End of Life (EOL) Change Notice #1410033

EOL Date: 10/3/2014		EOL Effective Date: 10/7/2015	
Title: Si3402-A-GM End of Life Change Notice			
Originator: John Wilson	Phone: 512-532-5755	Dept: APS Marketing	
Customer Contact: Kathy Haggar	Phone: (512) 532-5261	Dept: Sales	
PCN Type: End of Life			
Last Time Buy (Order) Date: 4/7/2015

Appendix: Si3402-B Compatibility with Si3402-A Reference Designs

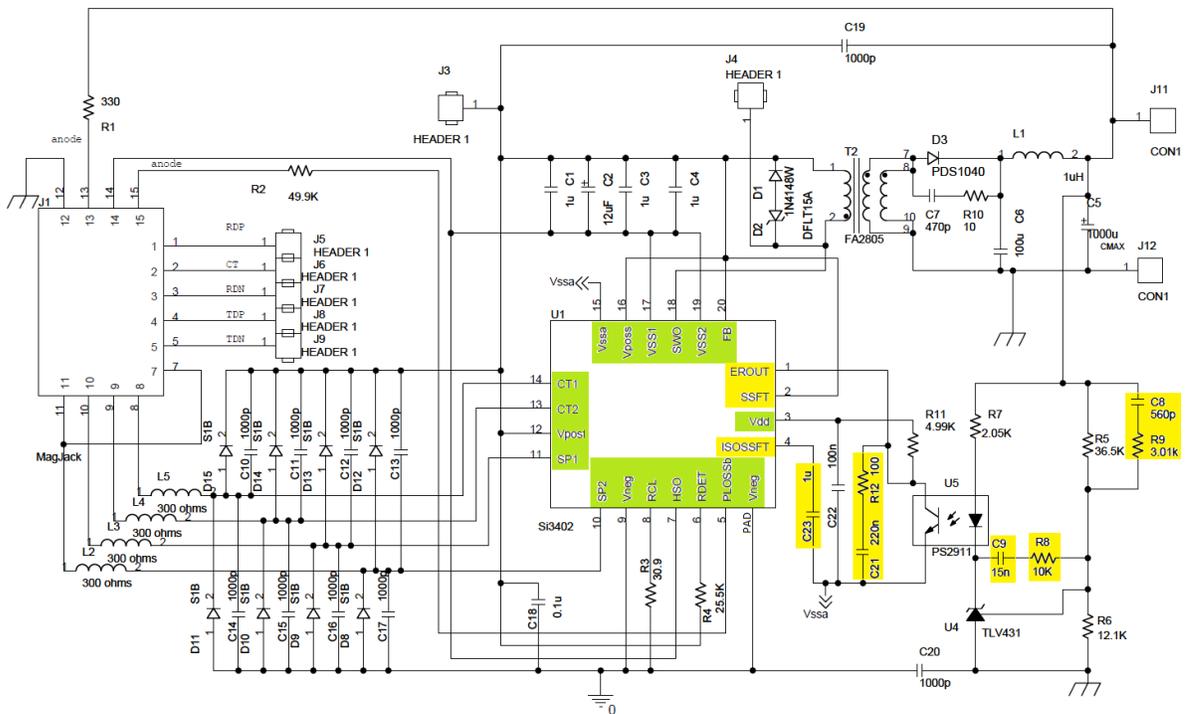
These notes address the compatibility of Si3402-B-GM (here called “Si3402-B”) with the Si3402-A-GM (here called “Si3402-A”) isolated and non-isolated reference designs. A later application note will provide complete details to guide customers through the Si3402-A to Si3402-B transition.

Green indicates compatibility is complete and no change is required.

Yellow indicates a Si3402-A pin whose function is modified, and related passive components whose values may need to change to accommodate the Si3402-B. The specific component value changes are not yet available. Affected pins are:

- SSFT, ISOSSFT – soft start is internal; soft-start capacitor may be removed or retained
- ERROUT – change to the internal PWM control algorithm may require changes to component values
